SUBJECT: **Request for Modification to Section 404 General Permit and Section 401 General Water Quality Certification** for the proposed US 421/I-40 Business pavement reconstruction, bridge replacements and interchange modifications from west of 4th St. to east of Church St., and a multi-use path from 4th St. to Liberty St., Forsyth County, Division 9. Federal Aid Project No. NHF-0421(5), TIP Project No. U-2827B / C-5620A. Debit \$570.00 from WBS 34872.3.4.

References: Section 404 General Permit 198200031, U.S. Army Corps of Engineers Action ID SAW-2009-01193, dated July 11, 2017; 401 Water Quality General Certification No. 4088, N.C. Division of Water Resources Project No. 20170732, dated July 13, 2017.

WETLAND AND STREAM IMPACTS
 SUBMITTED: 01-09-2018
 PERMIT MODIFICATION

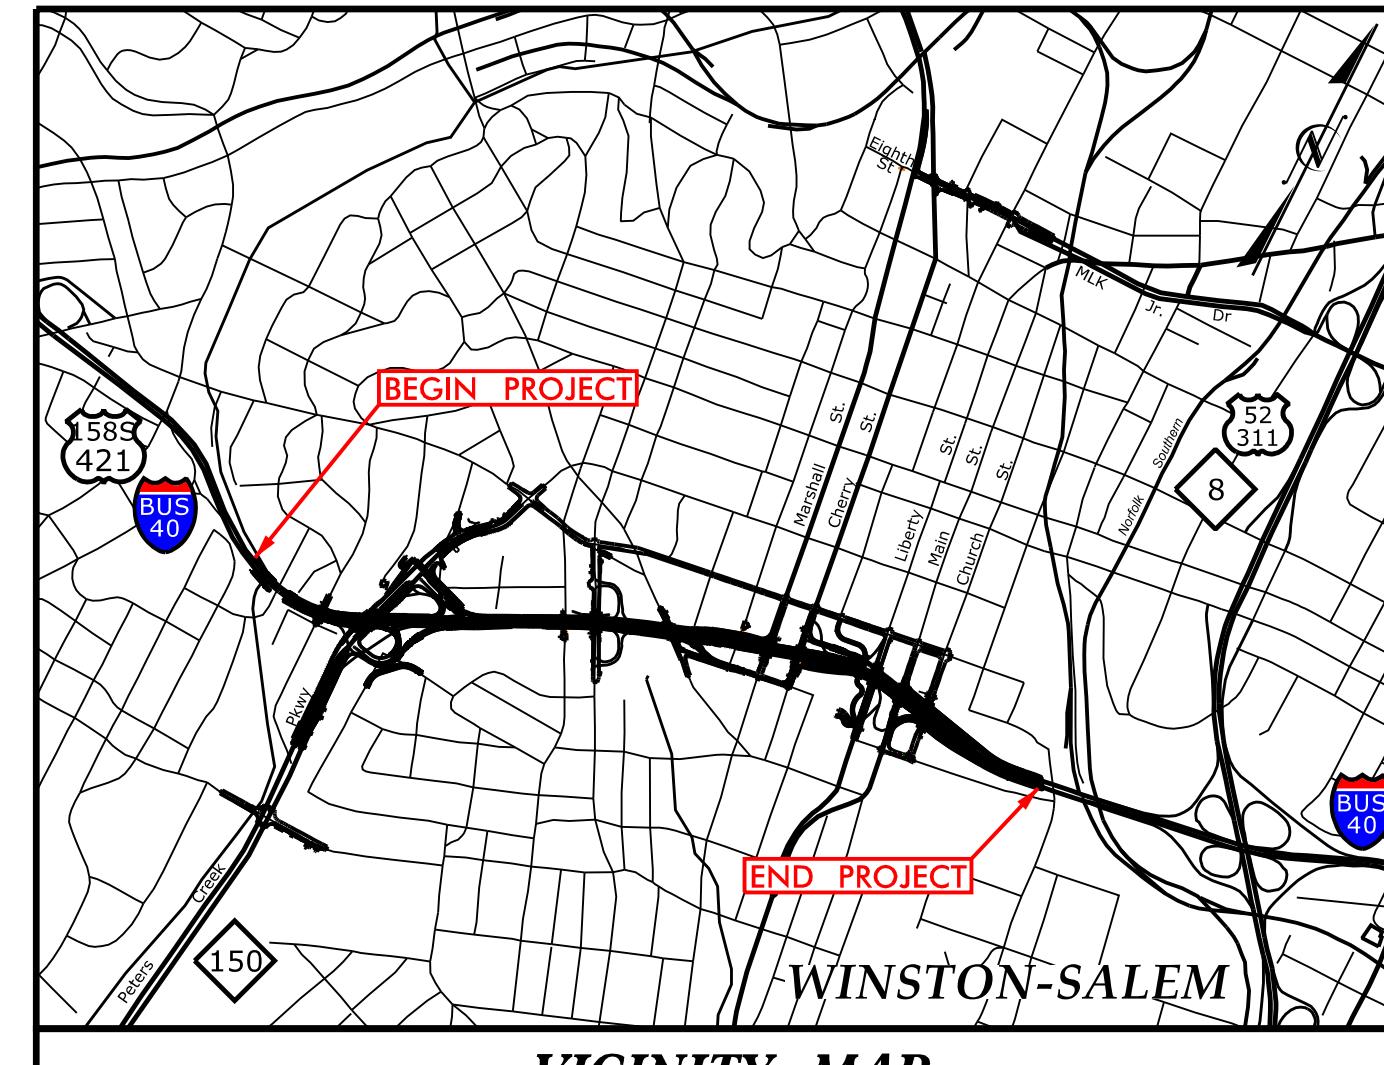
The previously permitted impacts were 380 linear feet of permanent stream impacts and 236 linear feet of temporary stream impacts. The revised total impacts will be 458 linear feet of permanent stream impacts and 216 linear feet of temporary stream impacts associated with construction of the project. Mitigation was originally only proposed for 347 linear feet of the 380 feet of permanent stream impacts (33 feet of the 380 was bank stabilization). The revised mitigation will be 458 linear feet of permanent stream impacts. Therefore, an additional 111 linear feet of permanent stream impacts will be needed. Mitigation for 458 linear feet of permanent stream impacts has been provided by NC Division of Mitigation Services (see attached letter).
